CITY OF UNALASKA

ADDENDUM 08

**SUBJECT: INVITATION TO BID
UNALASKA PYRAMID WATER TREATMENT PLANT – LT2 UPGRADE
PROJECT NUMBER: DPW # 13401**

CITY OF UNALASKA
 PYRAMID WTP
 INSTRUMENT AREA A ARRANGEMENT
 (FROM SHEET P2.1)

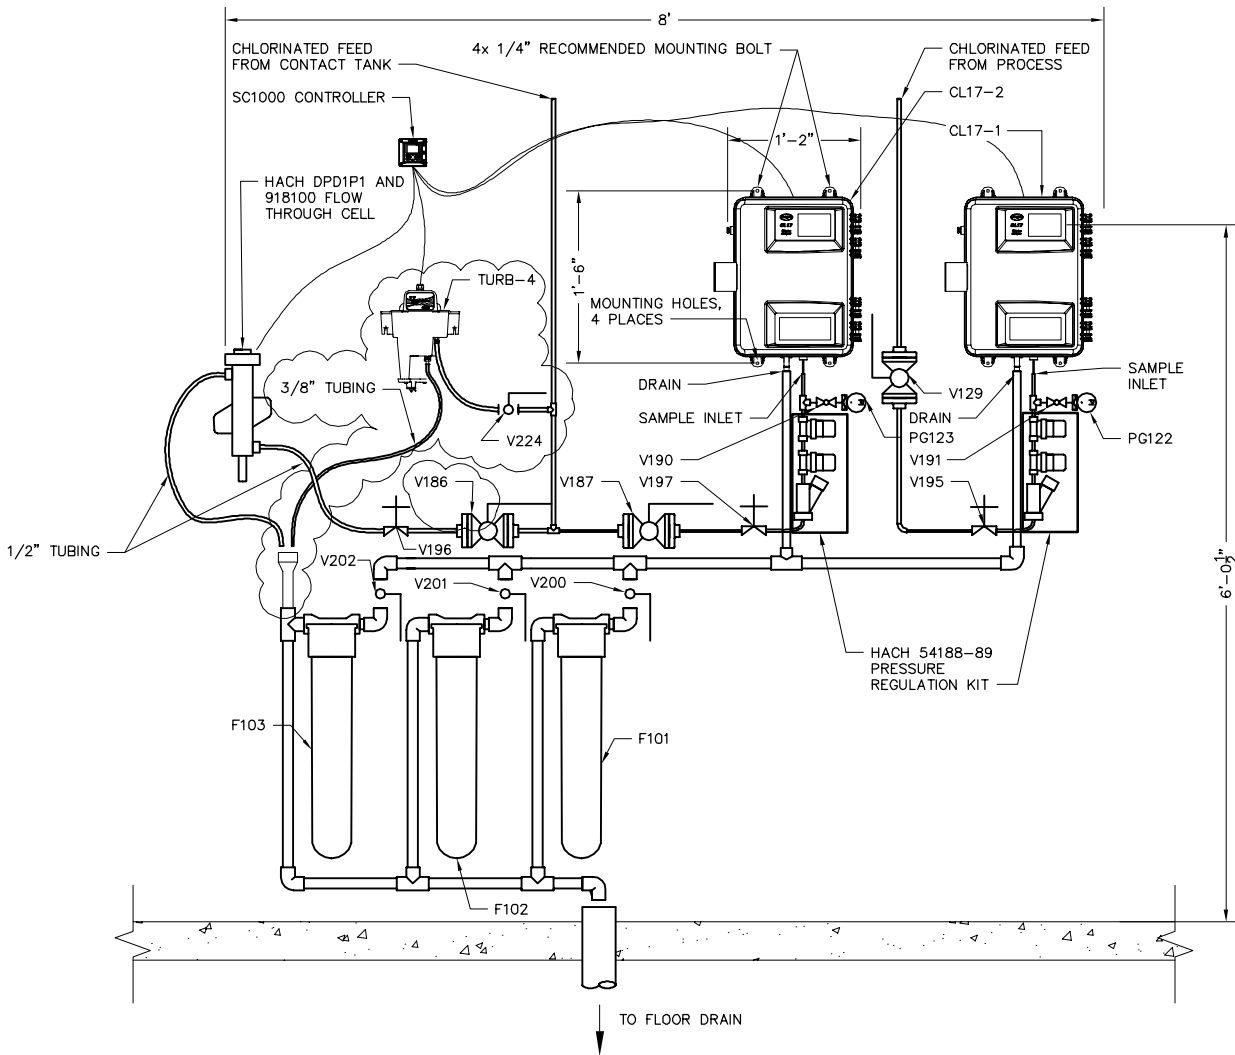
1. Sheet P1.6: Change “SM-101” to “SM-101, Komax 3-Element Hi-Pass 316 stainless steel mixer with 150 pound flanged ends, or approved equal”
2. Sheet P2.1: Replace Instrument Area A with attached sketch SKP-3
